CAMPAIGN 5599 - Service Campaign

Model: Fiat Freemont 2.0 JTD

- Various operations

ANNEX 2

Fig. 4 Clutch damper

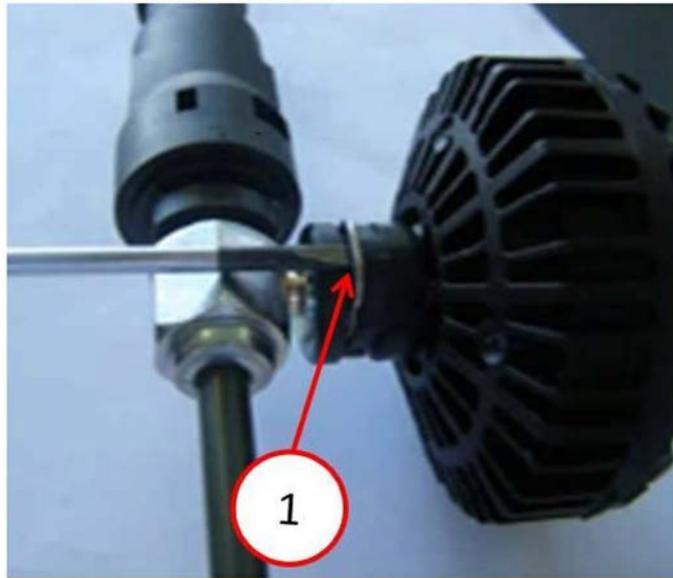
2. Stick your arm in with a small screwdriver.
3. Locate the damper and rotate it so that you can see the damper retaining clip (Fig. 4).

4. Pull the retaining clip out to the stop, remove the damper and discard it (Fig. 4) and (Fig. 5).

Fig. 6 Clutch cap

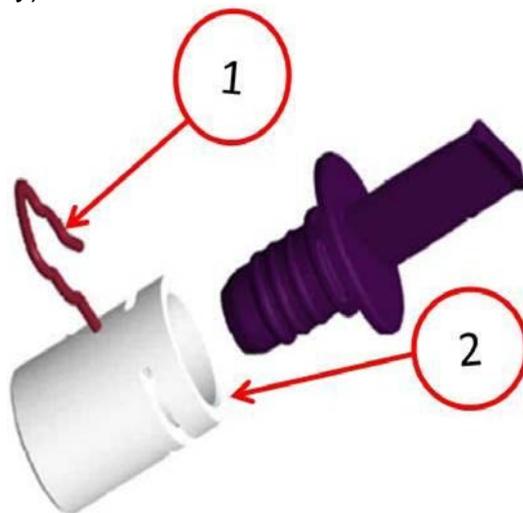
5. Install the retaining clip onto the new cap, p/n K68166291AA (Fig. 6) (see Part&Service availability).

Fig. 7 Hydraulic line with cap

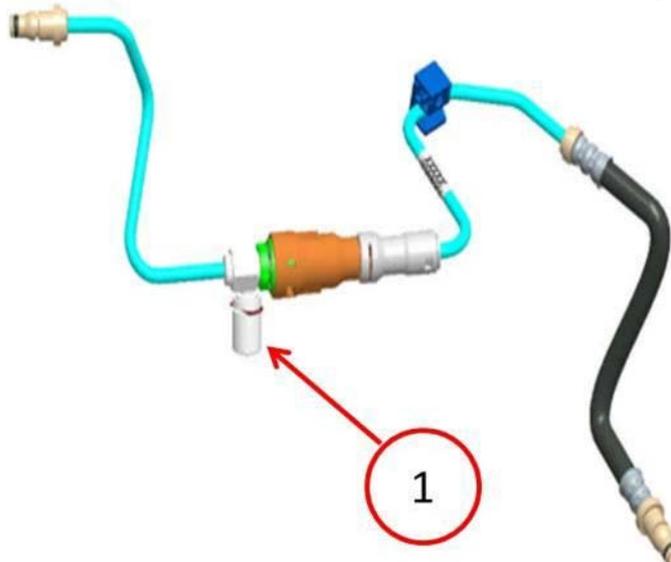
6. Install the cap onto the hydraulic line in place of the damper (Fig. 7).
